STAFF COMMENTS

HEARING DATE: February 13, 2025

A-24:278 — 16–22 King Street East, Dundas

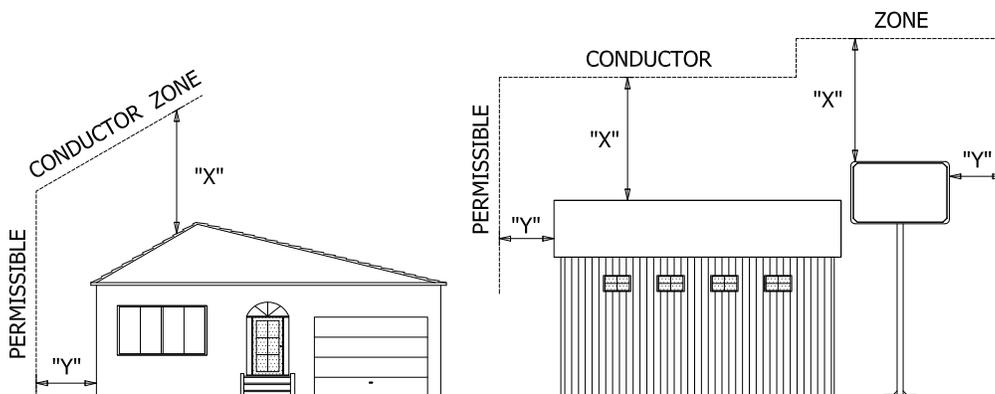
- Minimum 4m horizontal clearance from existing O/H line(s) must be maintained at all times as per Alectra Utilities Standard 3-105. Please consult with Alectra Utilities if further clarification is required.
